Sydney Olympic Park New High School

Architectural Response to SDRP Report

Spaces for passive recreation and small groups

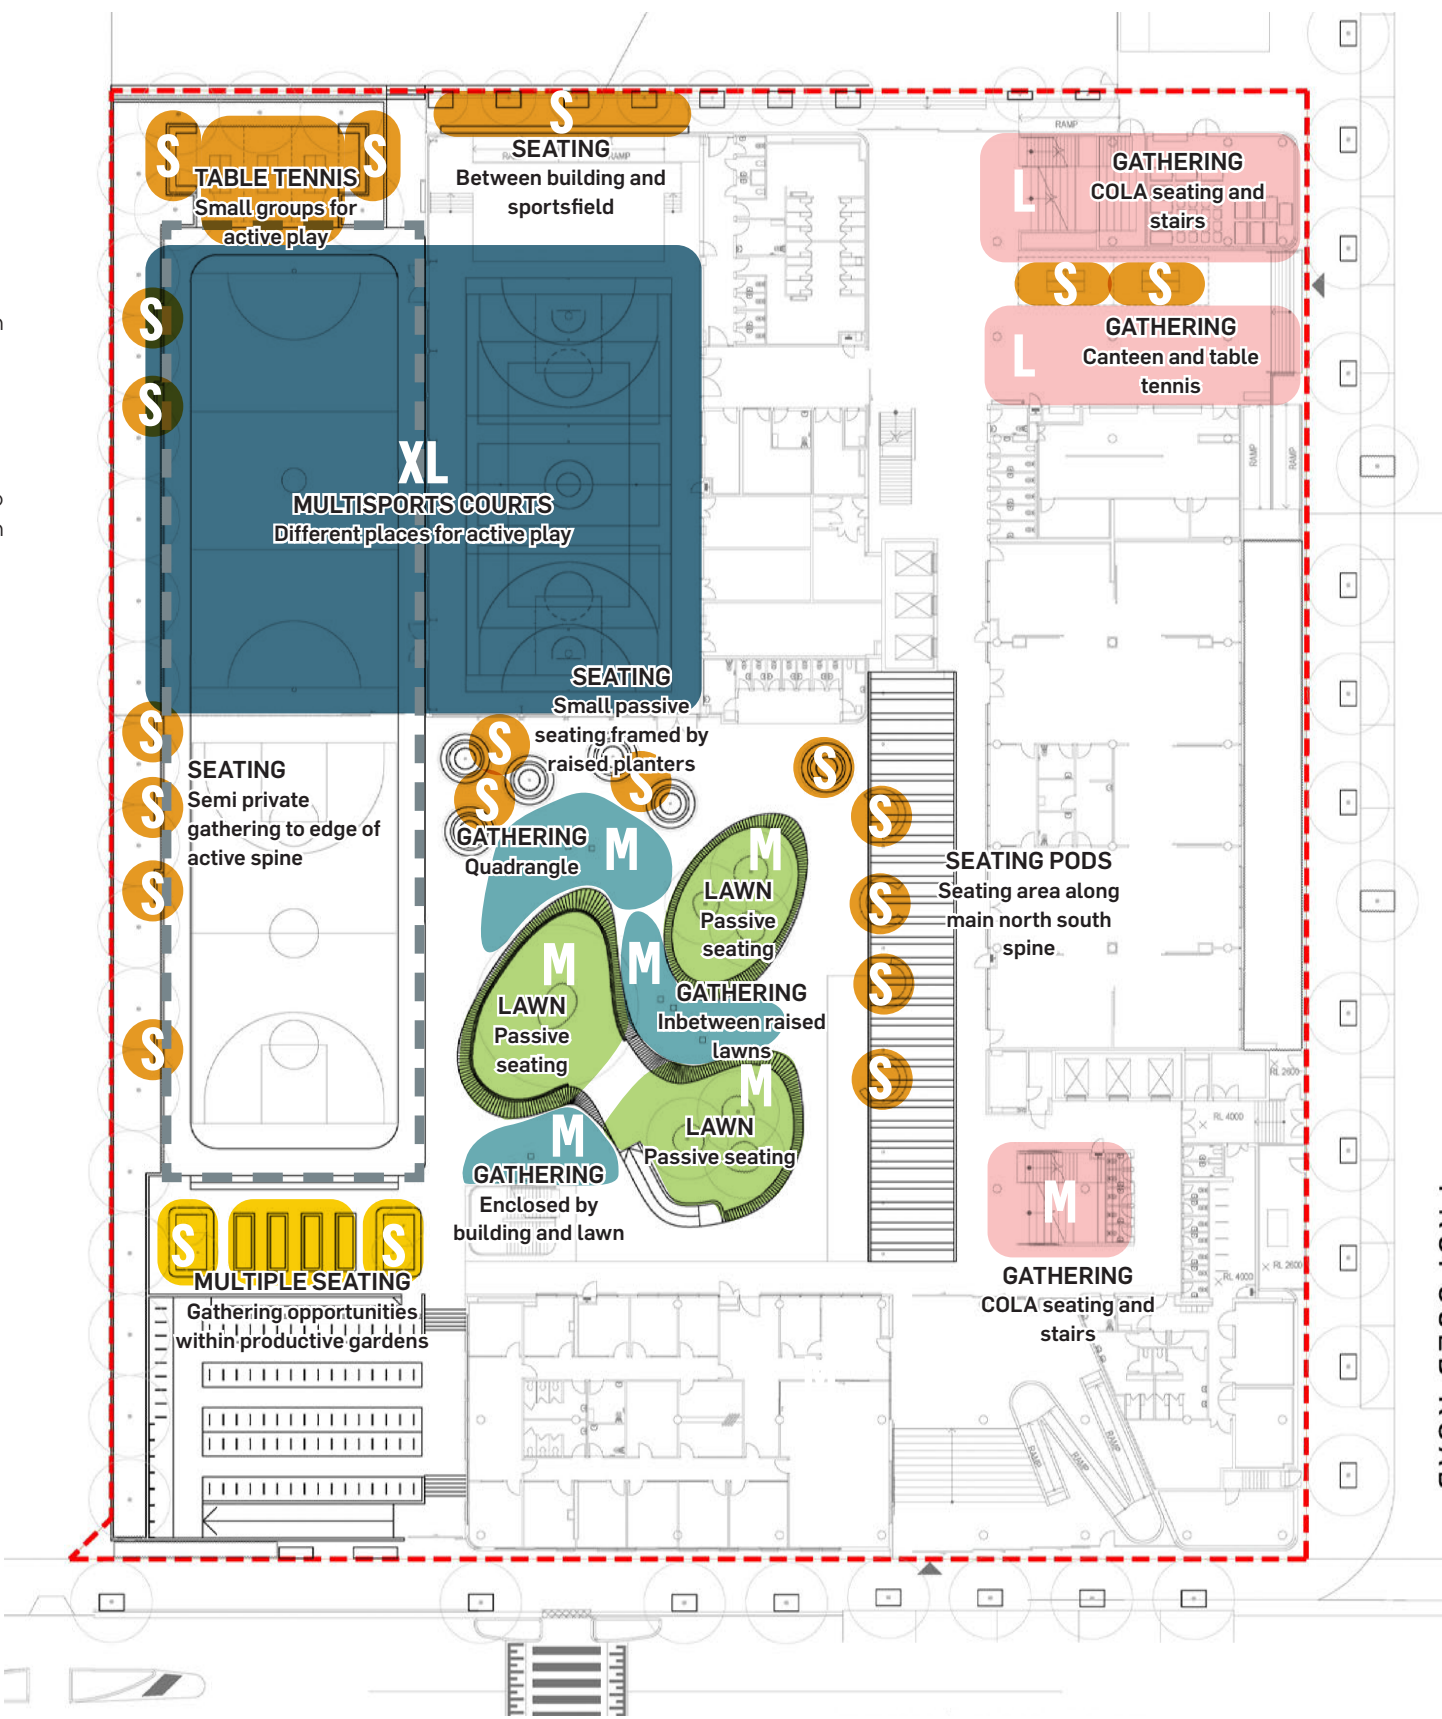
Comment: Character – Illustrate opportunities for passive recreation and small group gathering areas to be incorporated within the landscape, in particular along the north and west boundary edges.

The landscape design provides opportunities for a variety of gatherin spaces at different sizes and scales. These spaces cater for a wide range of uses including formal and informal gathering and social zones, learning programs an play areas.

Two table tennis tables have been removed from the northern boundary (relocated to the northern COLA) to provide two passive recreational gathering areas for small groups.

Seating benches have been added along the western boundary to provide opportunities for respite on the edge of the courts for small groups. Urbis have updated the Gathering Spaces diagram to illustrate the character and programs of the gathering spaces, this includes the reduction of the bicycle parking which has provided an opportunity to create an enhanced First Nations productive garden and passive recreation.

Gathering spaces - modes of use and capacities

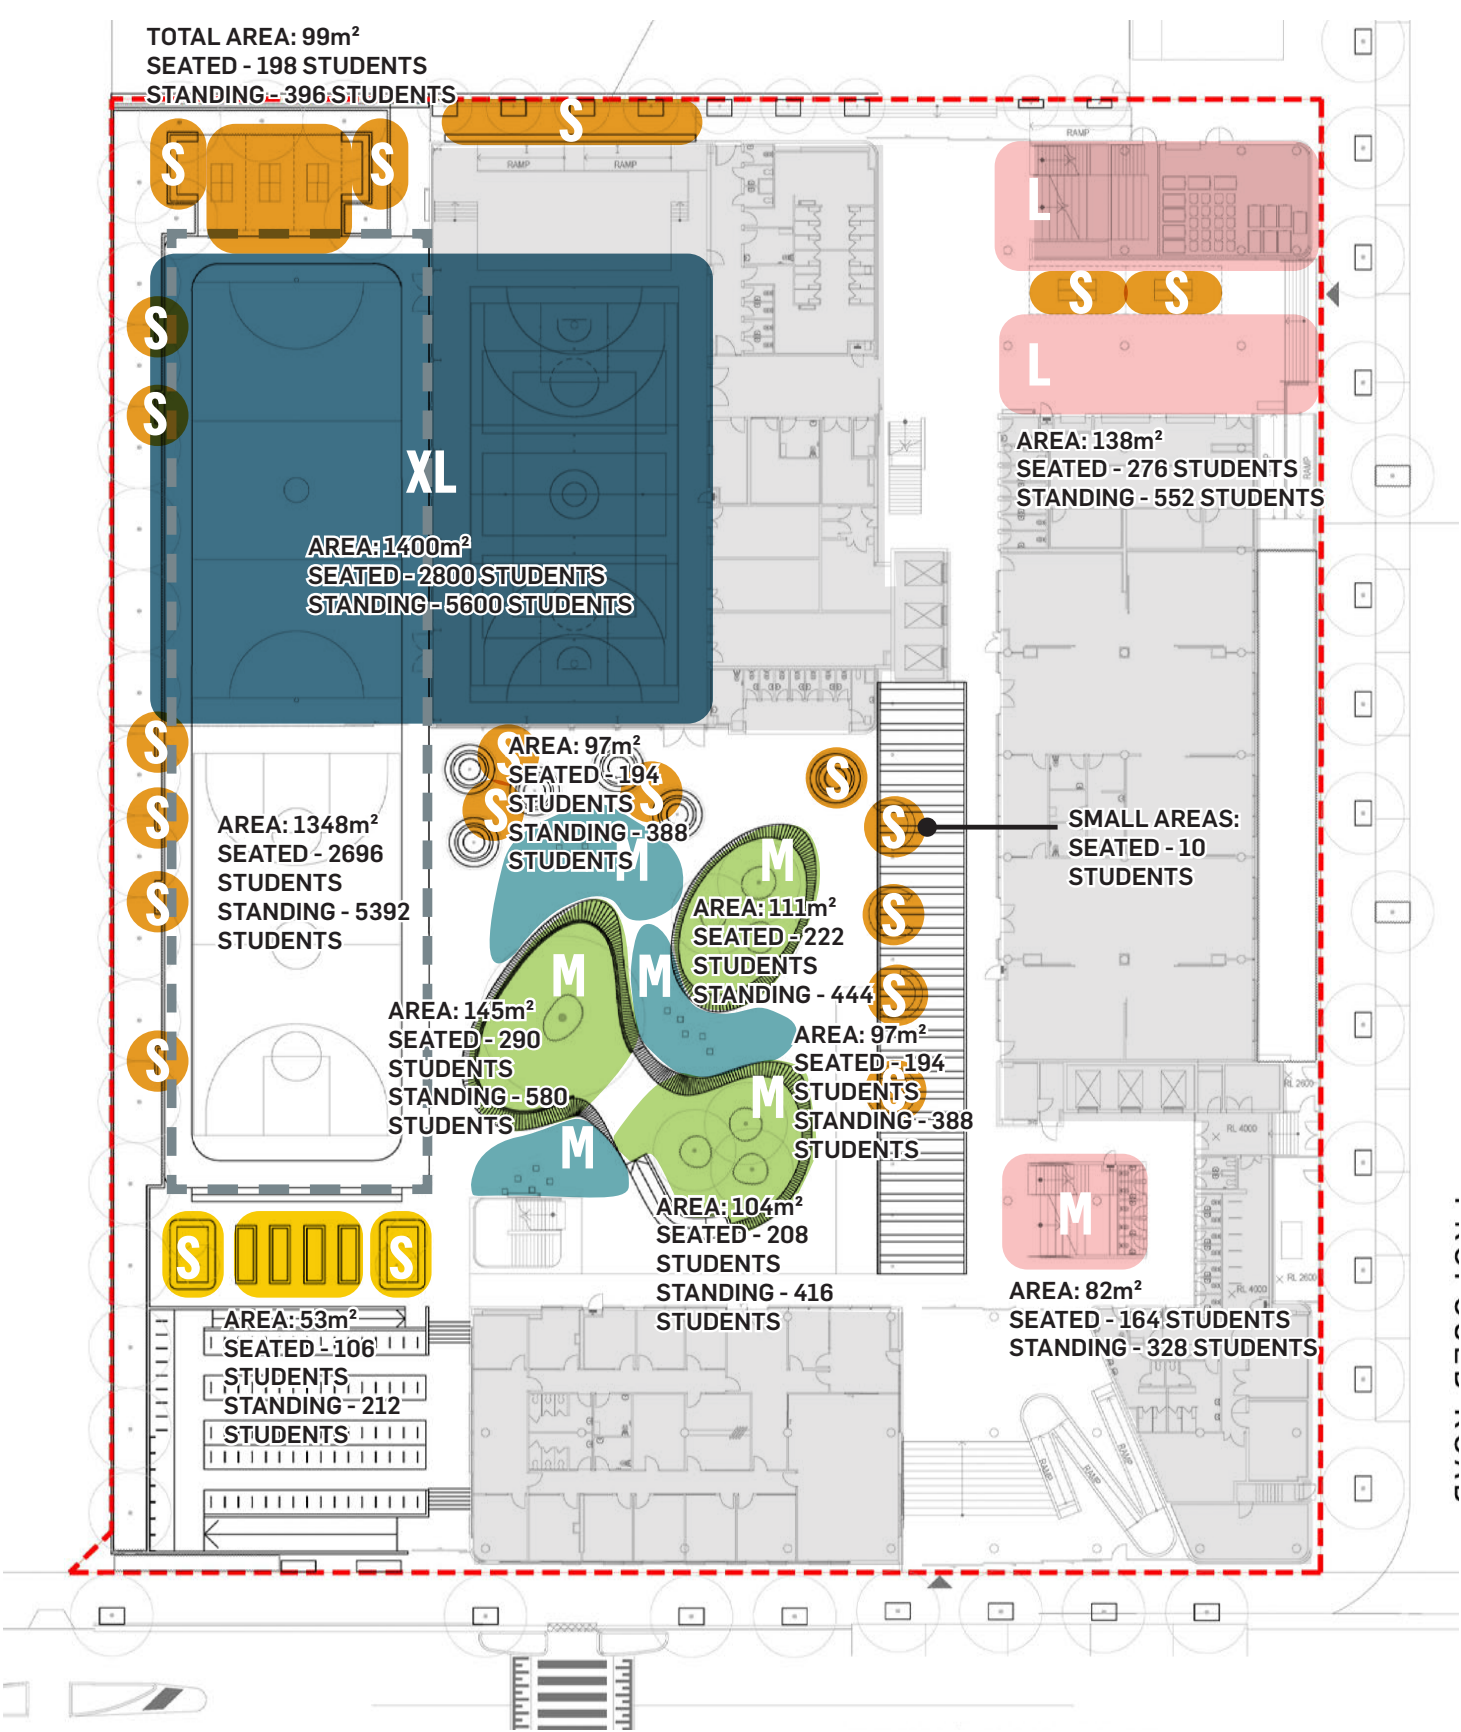
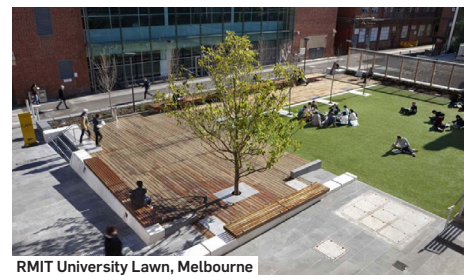
Comment: Gathering spaces – Illustrate the modes of use and number of people that can be accommodated in the various gathering spaces and open areas, particularly in the central courtyard.

Urbis have added a Gathering Spaces Use and Number of People diagram to illustrate the capacity of the small, medium, large and extra-large spaces.

Boundary conditions

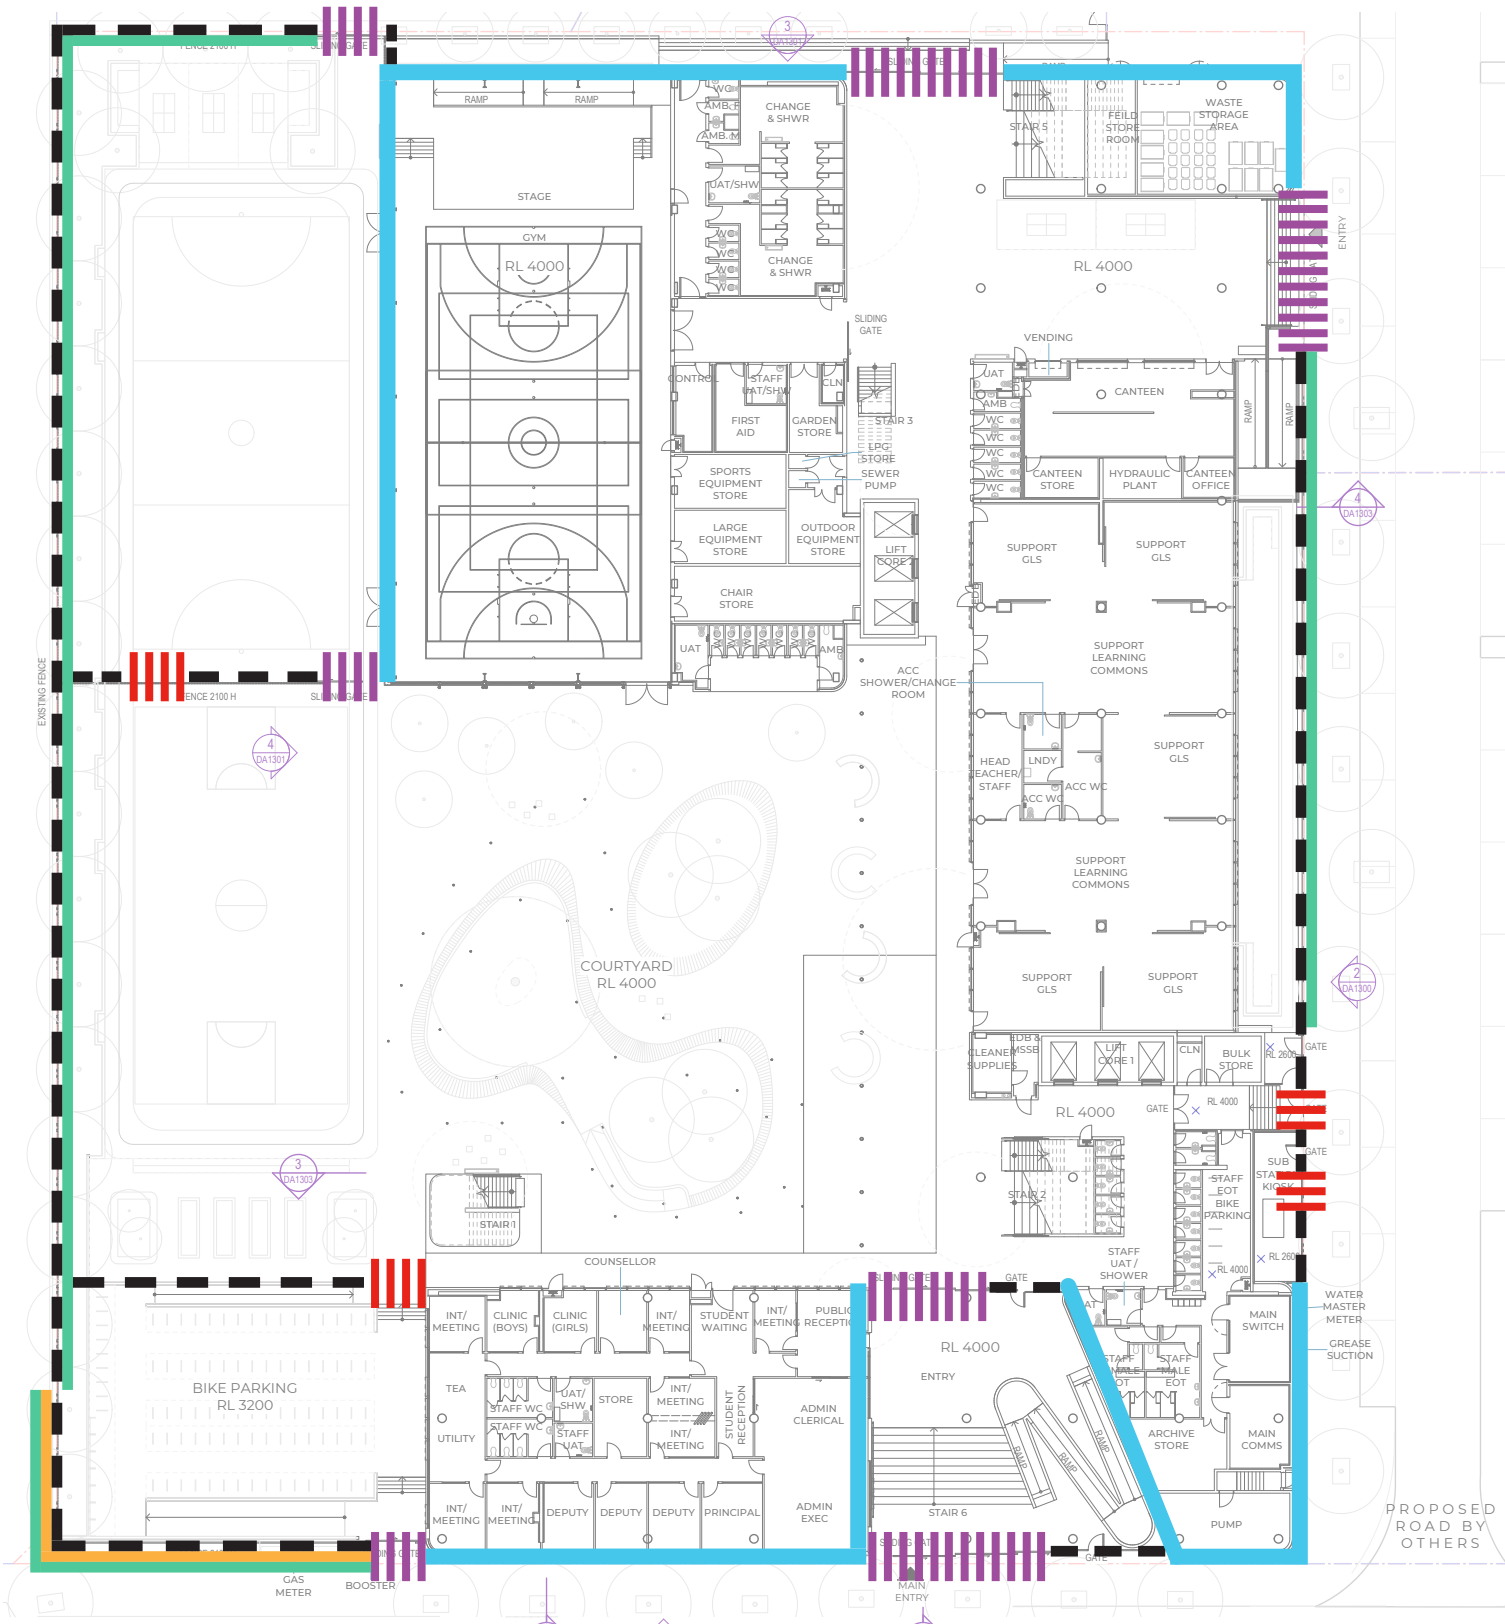
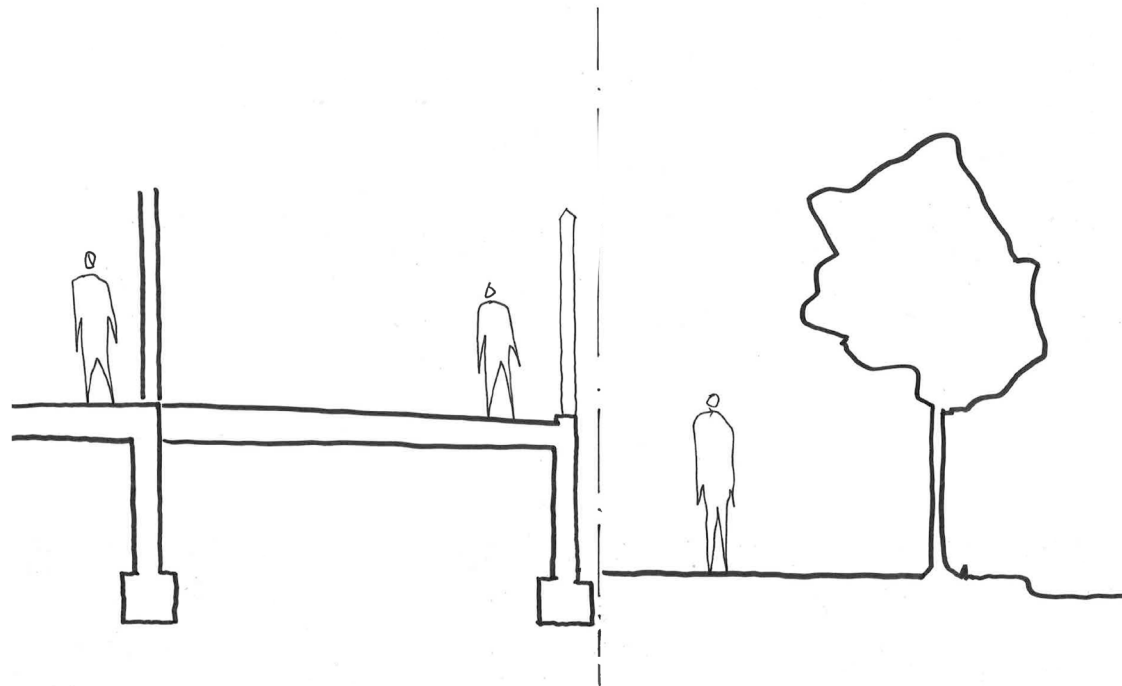
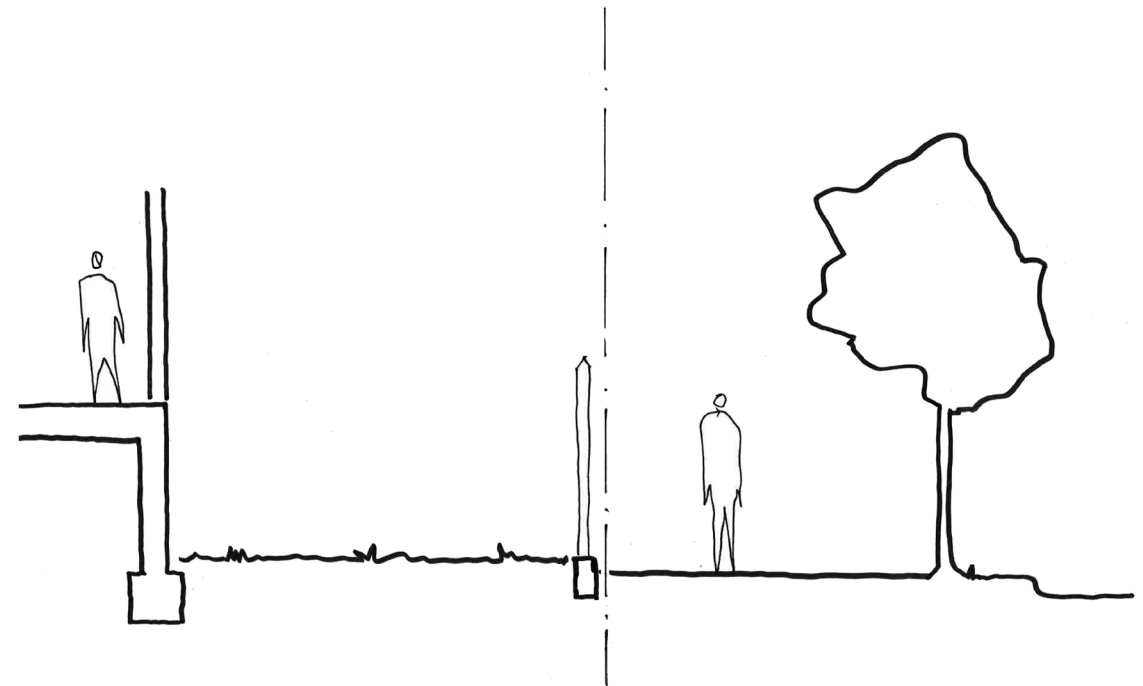
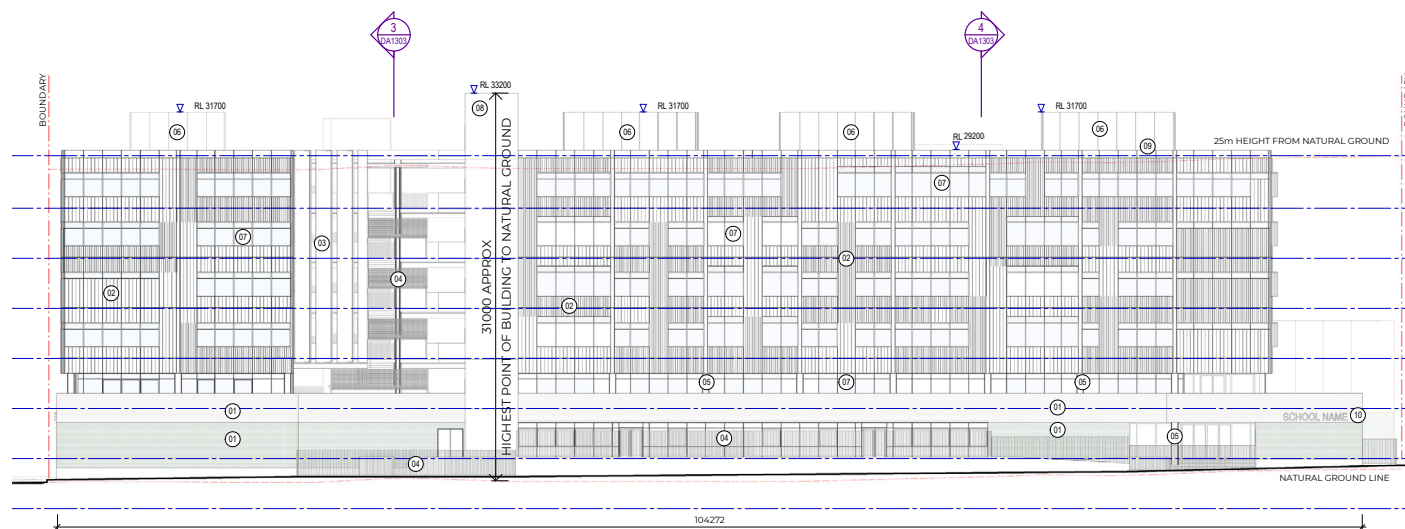
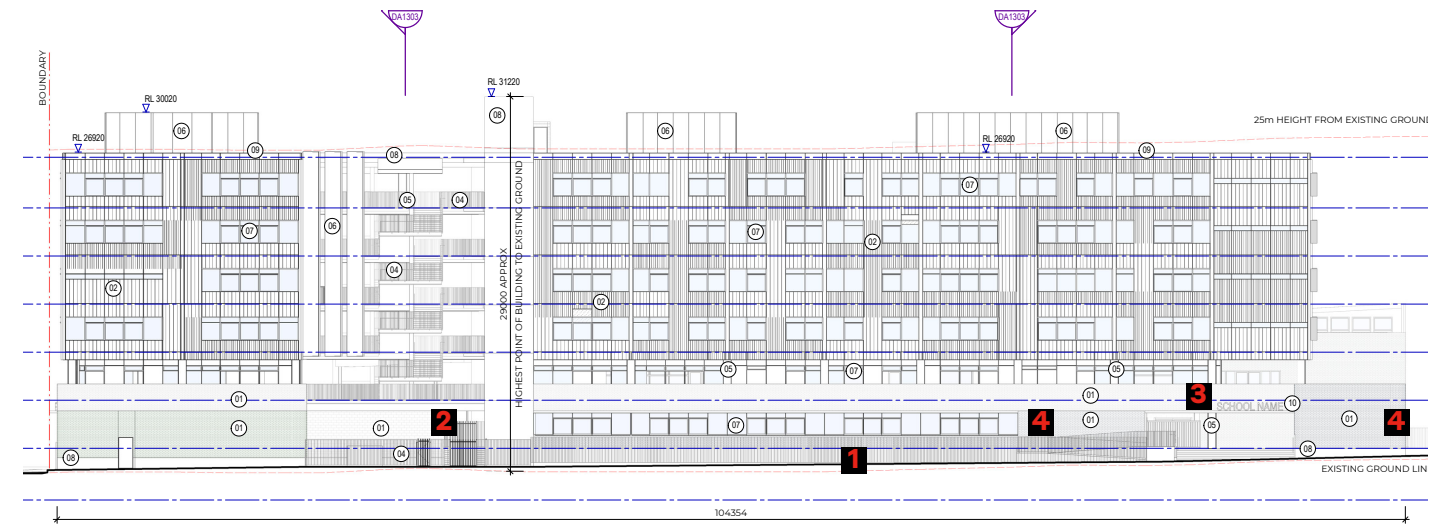
Comment: Building as boundary – The fences along the boundary of Eastern Road appear unwelcoming and are an inappropriate urban response. Undertake further design development to enable the building to define the urban edge. Provide a diagram clearly indicating the extent, height and character of all proposed fencing lines.

The design has evolved since the SSD submission. The building is setback from the boundary ensuring a large distance from the eastern road.

As the design evolved, there is no longer a requirement for a dedicated support learning play area, but instead a need for a better integration to the main building. The removal of the retaining wall which was supporting this outdoor play area – an unarticulated, opaque barrier – allows a generous planting while also defining the school's interface with the eastern road. The result is an edge condition that is better scaled and more sympathetic to pedestrians. The landscaped area acts as a generous buffer between the support learning unit and the public domain. The palisade fence remains as a requirement for school security – it protects the windows of the support learning unit, which are too close to the ground to be properly secured.

Another change along the eastern road boundary is the removal of the projecting canopy over the school entry point at the north-east corner of the site. The canopy is now a simple undercroft, aligned with the building at the canteen and support learning unit. As a result, the entry point is now a clearer and more legible element within the overall massing.
